FOUR CORNERS POWER PLANT
Lined Ash Impoundment,
Lined Decant Water Pond,
Combined Waste Treatment Pond,
Upper Retention Sump, and
Dry Fly Ash Disposal Area

Annual
CCR Impoundment and
Landfill Inspection Report

2017

20171113 – IMG_1877
Repairs of the geomembrane liner along the western portion of the South Embankment.

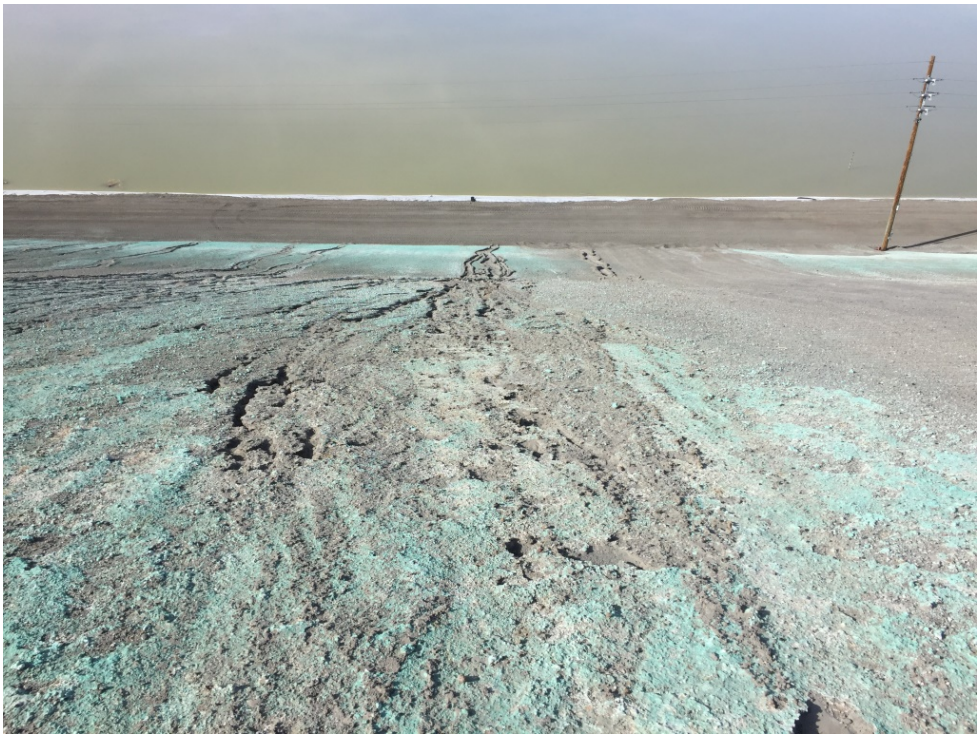
ii. The liner is bulging along the western portion of the South Embankment. In early summer, APS discovered several tears in the liner when the water level in the LAI was higher. APS repaired the tears in October (photo IMG_1877), but water had already entered the space between the liner and the compacted clay along the upstream slope. The water migrated down the liner/clay contact and lifted the liner along the ponded water level (photos IMG_5216 and IMG_5228). APS has since been drawing down the water level in the LAI. The LAI embankment was designed to be stable without the geomembrane liner (URS 2012); however, the upstream slope and the toe drain along the South Embankment should be monitored for evidence of internal erosion. Evidence could include benching along the upstream slope due to the erosive action of water against the clay and cloudy seepage flowing out of the toe drain. The South Embankment toe drain was dry on the date of this inspection (photo IMG_5353).

20171113 – IMG_1884
Minor erosion rills along the downstream slope of the West Embankment.

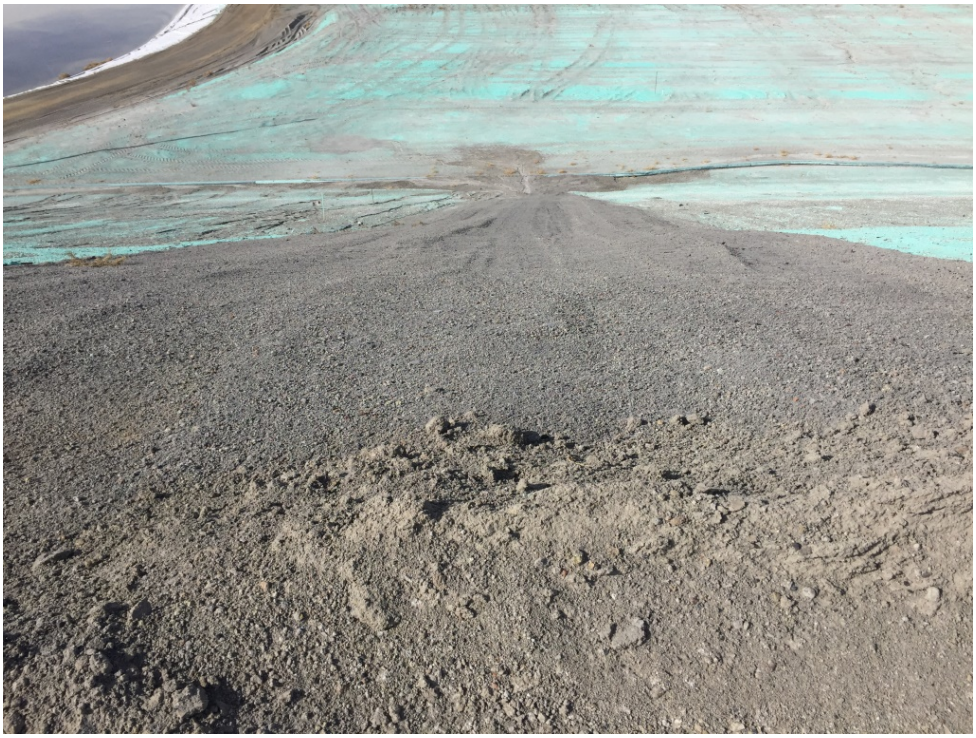
iv. The downstream slope of the West Embankment had recent erosion repairs (photo IMG_1886) and minor recent erosion rills. These local erosional features may require repair in the future (photos IMG_1884 and IMG_1887) and should be monitored.

20171113 – IMG_5411
Repaired area of the liner, observed pulling out of the anchor trench during the 2016 inspection.

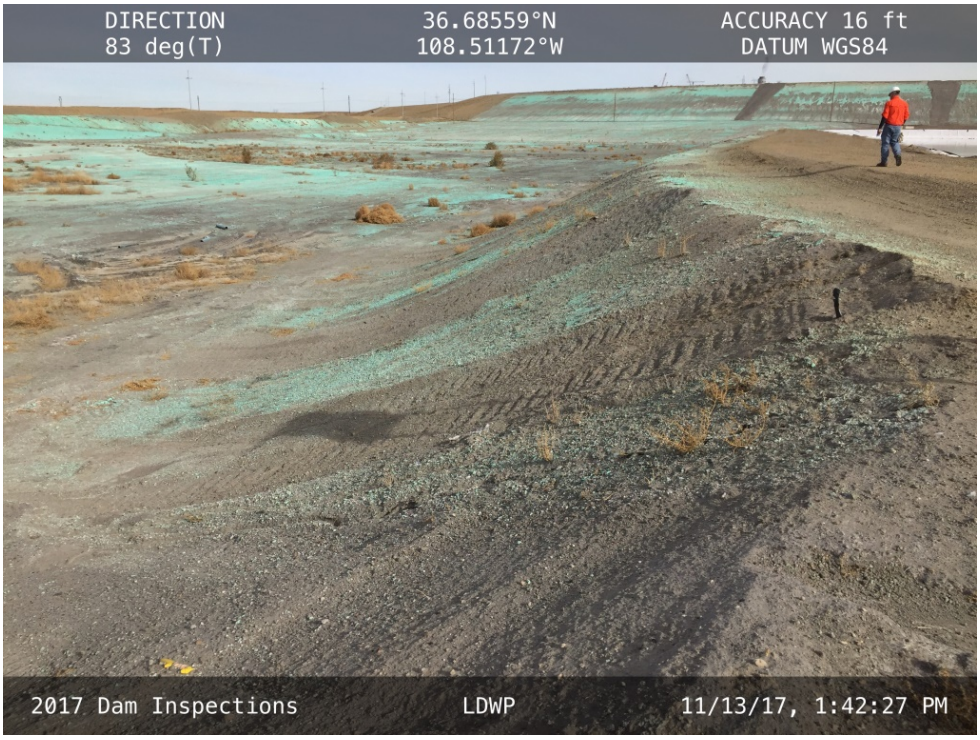
v. The liner was observed to be pulling out of the anchor trench in isolated areas along the West and East Embankments (photos IMG_5408 and IMG_5435). The area where the liner was observed pulling out of the anchor trench during the 2016 inspection has been repaired (photo IMG_5411).
